**California Endangered Species Act
Amended Incidental Take Permit No. 2081-2021-015-06
(Amendment No. 5)**

CRIMSON SOLAR PROJECT

CDFW now reissues this ITP including the revised provisions in this Major Amendment (Collectively, the Amended ITP). The Amended ITP includes all of the operative provisions as of the effective date of this Amended ITP. Attachment 11 to this Amended ITP shows the specific red-line changes made to the ITP as a result of this Major Amendment.

Figure 4b: Site Plans with Borrow Pit Locations

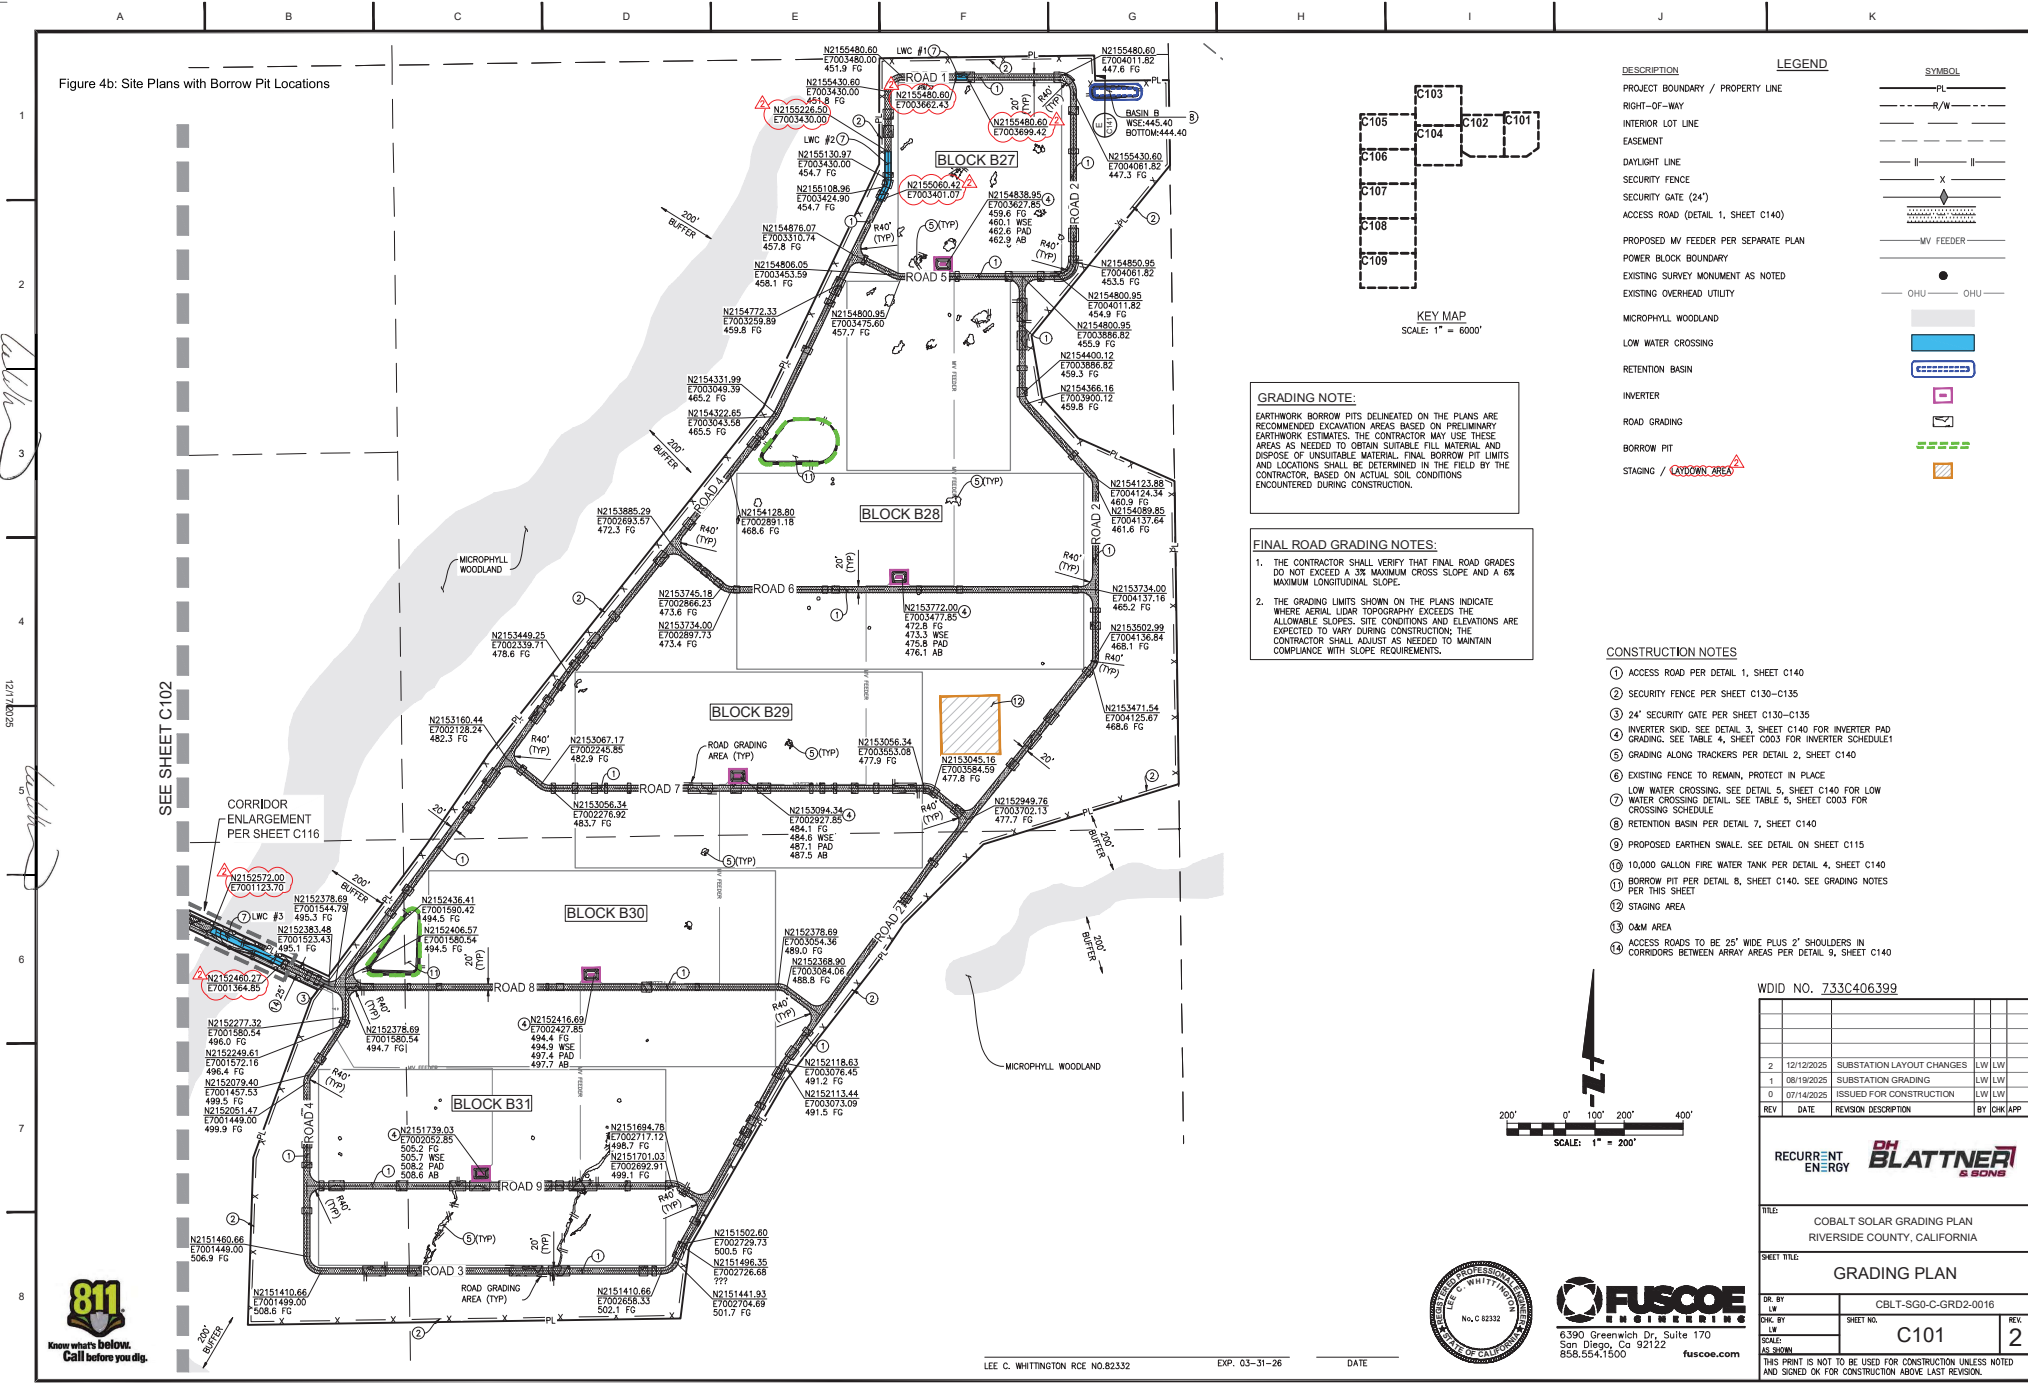
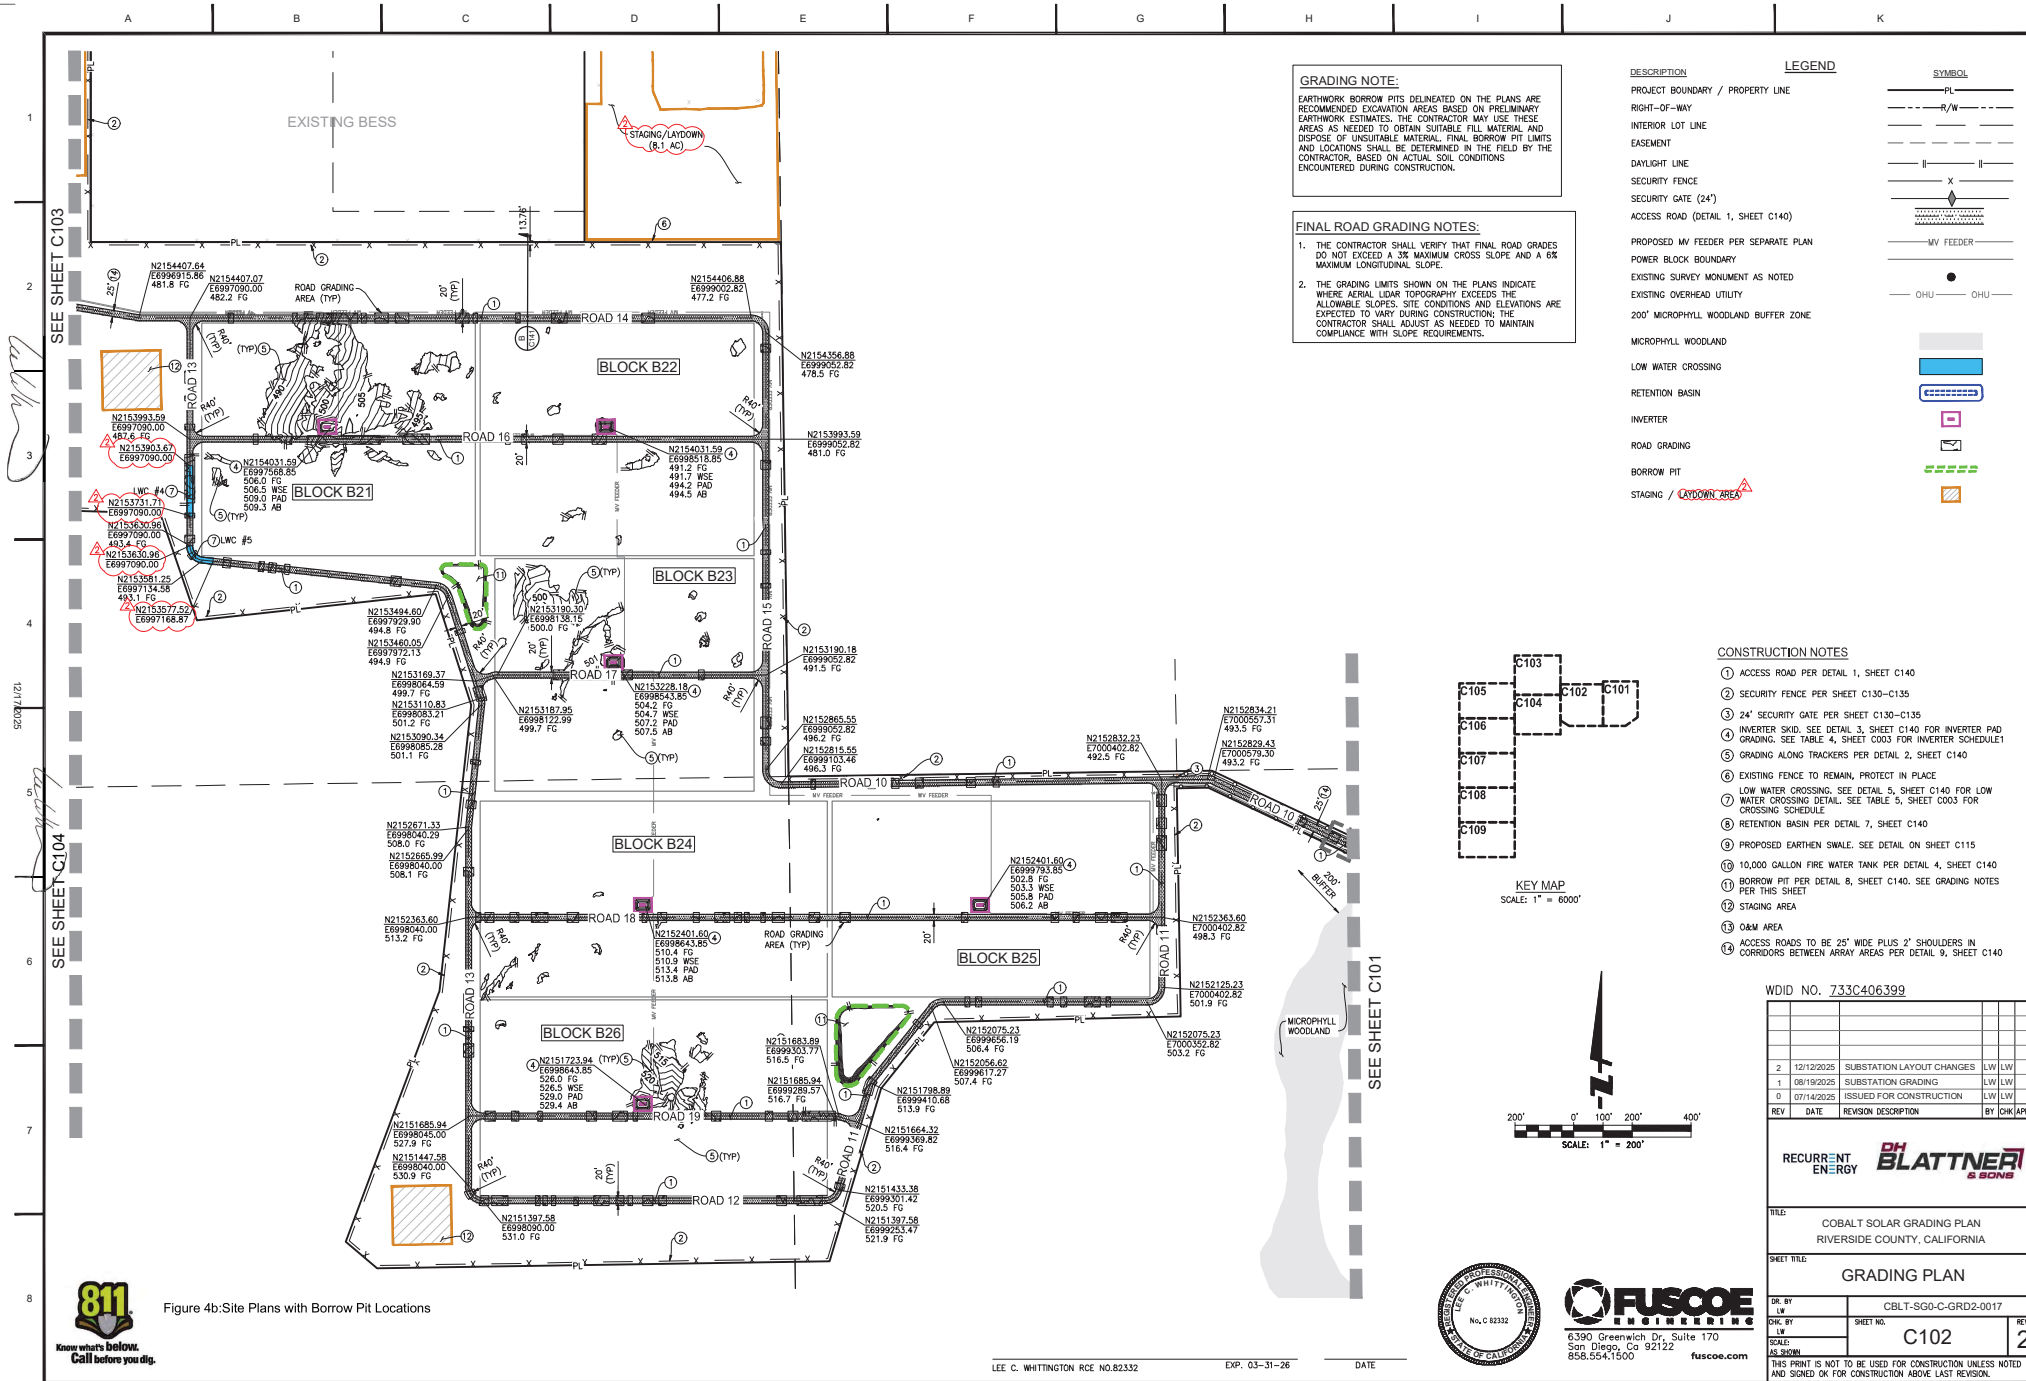
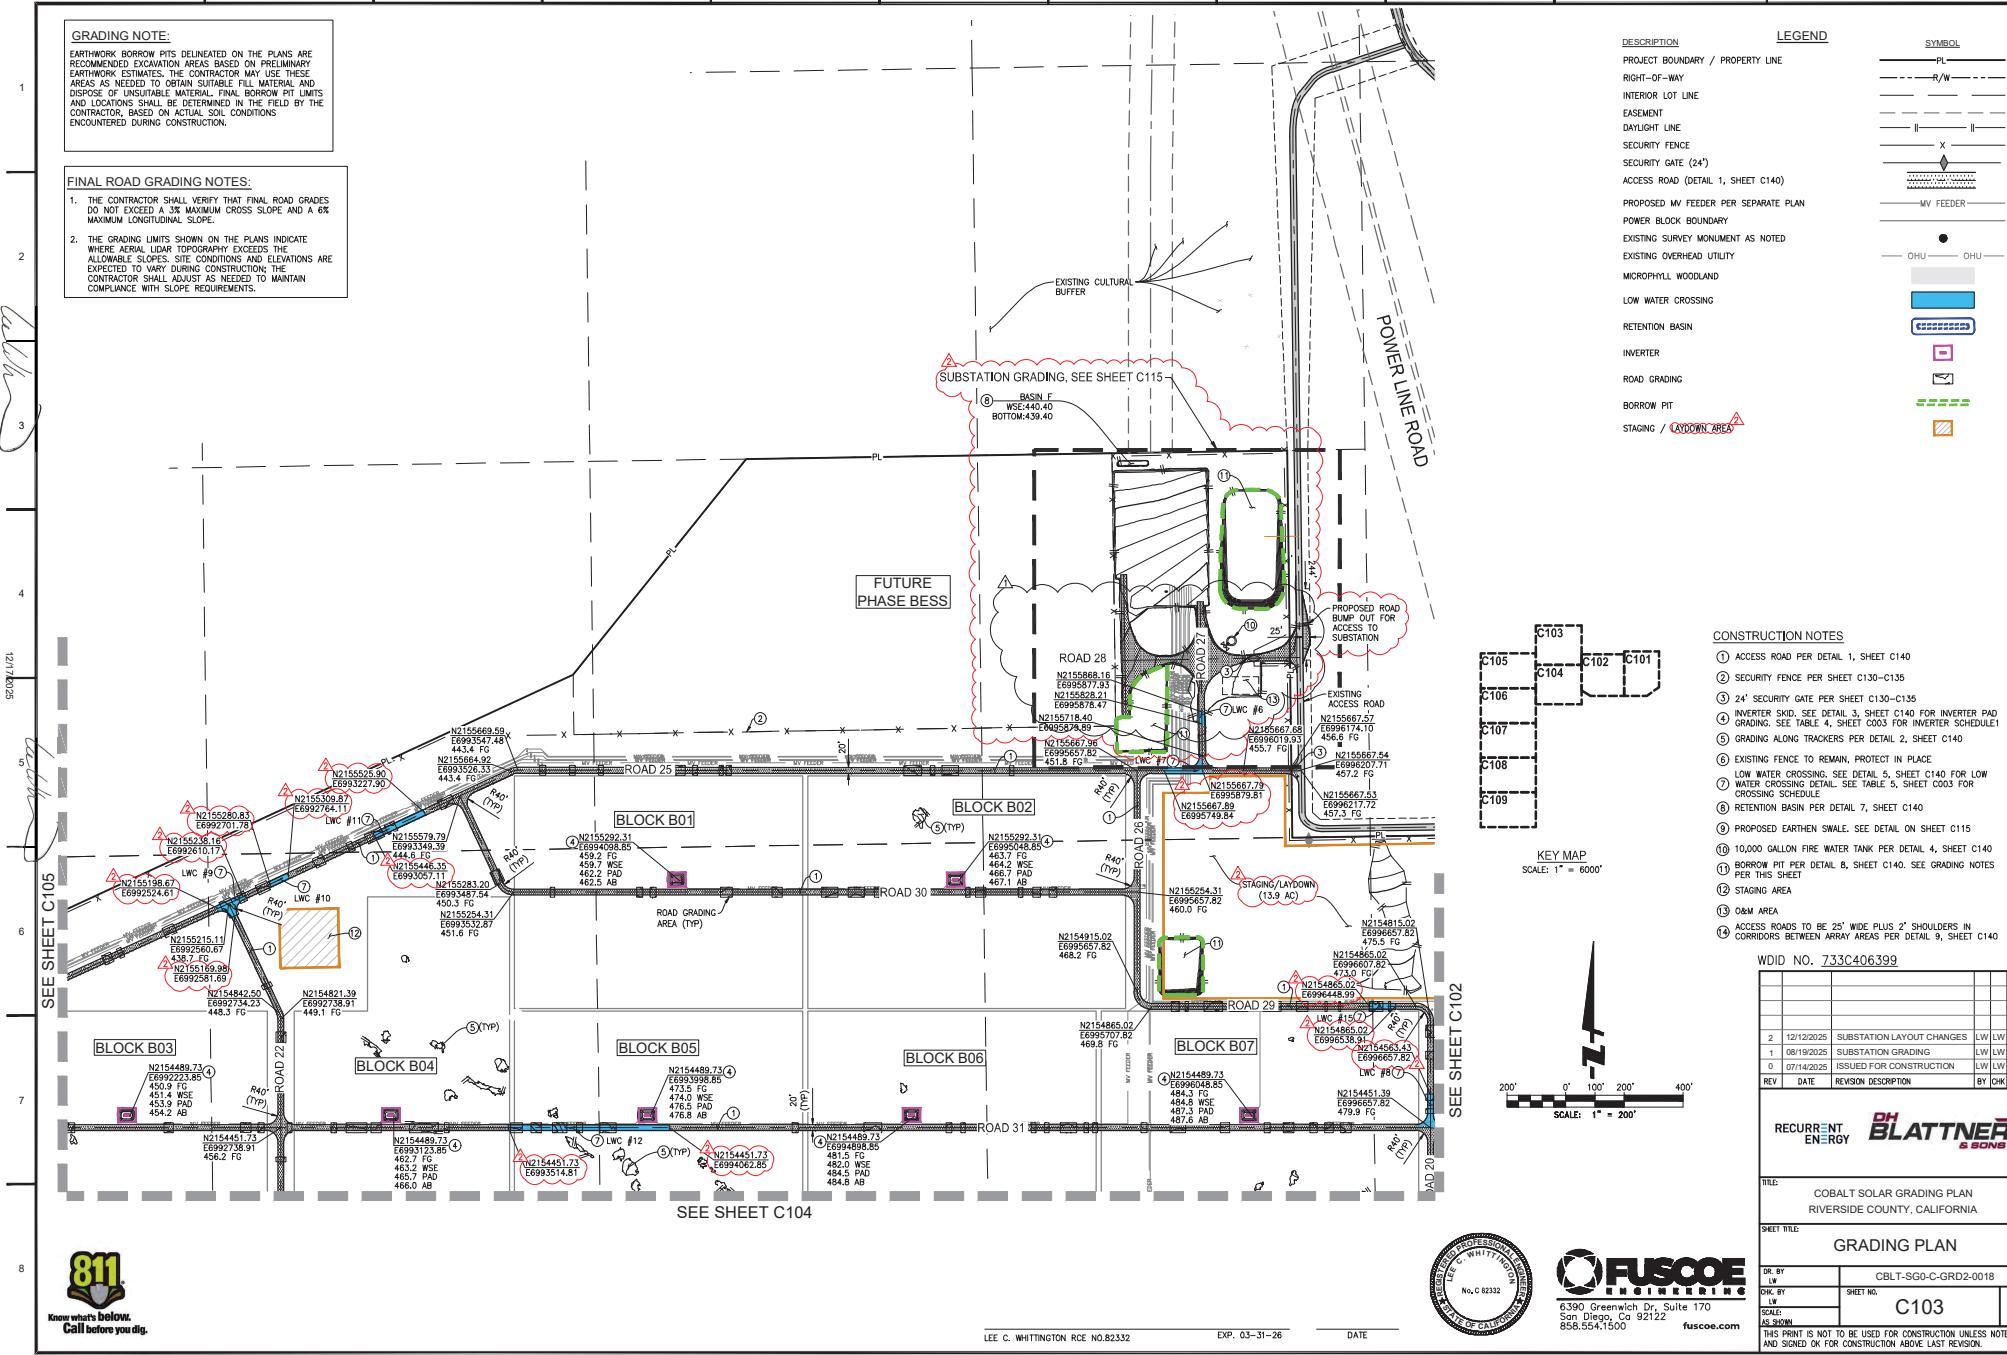
- (1) Updates to the Project Description to include the addition of borrow pits in the solar array area and modification of Condition of Approval 8.19 Borrow Pits to remove the language prohibiting borrow pit use and outlining a minimization measure for use of borrow pits.

The Project would establish up to twenty-five borrow pits distributed across the fenced solar array fields to source native fill material that would be needed for the construction of Project components such as access roads, inverter pads, sub-station pads, and O&M buildings (Figure 4b). Each borrow pit would be approximately 0.5 acres, totaling up to 12.5 acres of

borrow pit sites. Following extraction of native fill material, borrow pits would be recontoured and revegetated consistent with the surrounding landscape. Topsoil would be harvested at each borrow pit and temporarily stockpiled until after fill material is extracted. Structural fill material would then be excavated from the pit to achieve gradual 3:1 side slopes to depths ranging from 1 foot to up to 12 feet, depending on fill quality and topography at each borrow pit location (Figure 5). Once borrow pit excavation is complete, the borrow pit area would be regraded to achieve more natural slopes that tie into the surrounding landscape. Following recontouring, the stockpiled topsoil would be spread across the restored area and revegetated with native species consistent with the surrounding landscape.
